DW/BG
15391
2 February 2017

**RESPONSE TO SUBMISSIONS ADDENDUM - SSD 7445
SITE 9, SYDNEY OLYMPIC PARK**

We write to provide the NSW Department of Planning and Environment (DPE) with an update to the Response to Submissions (RTS) following the public re-exhibition of SSD 7445 application between 2 November 2016 and 1 December 2016.

Figure 1 – Building envelopes under SOP Master Plan (2016 Review) along Olympic Boulevard

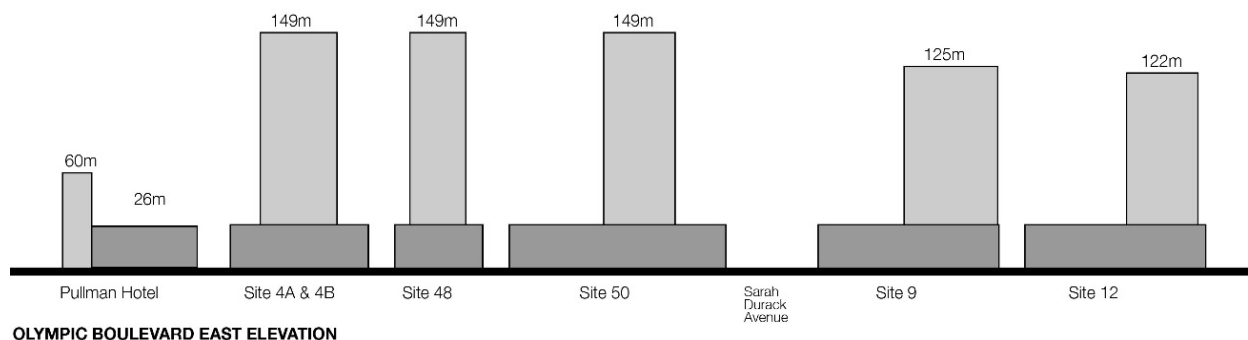
- *Provide further consideration of the proposed building height having regard to the maximum height provisions in the recently exhibited Draft SOP Master Plan.*
- *Provide consideration of opportunities to increase active land uses to provide further screening and passive surveillance on the levels provided with the above ground car parking.*

“The proposal is above the allowable height of 122 metres by 3.05 metres, not including the lift overrun. The proponents argue that this is only 1.3 metres above the original proposal, which did not have approval. Some of this height is caused by the addition of an apartment on the roof, which the proponents state, cannot be seen from the street. The height that will be visible from the street will be the parapet, which is 2.75 metres above the maximum height. It is considered that the Masterplan, which has had significant consideration and consultation should be upheld in terms of height. The impact of the extra FSR is not considered significant if the height can be reduced to adhere with the Masterplan”

The Sydney Olympic Park (SOP) Master Plan 2030 (2016 Review) was placed on public exhibition in October 2016 and has identified a significant increase the building height for sites north of Site 9 along Olympic Boulevard (ie sites 4A, 4B, 48 & 50) from 122m to 149m. Whilst the maximum building height on Site 9 and Site 12 remain at 122m.

Accordingly, when considering the proposed development in context with the future building envelopes north of the site along Olympic Boulevard that can achieve building heights up to 24m higher under the 2016 Review, the proposed variation sought to the 122m building height development standard is considered minor and would not give rise to adverse streetscape or built form outcomes for Sydney Olympic Park and is considered consistent with the desired future character of the locality (refer to building envelope diagram below at **Figure 1**).
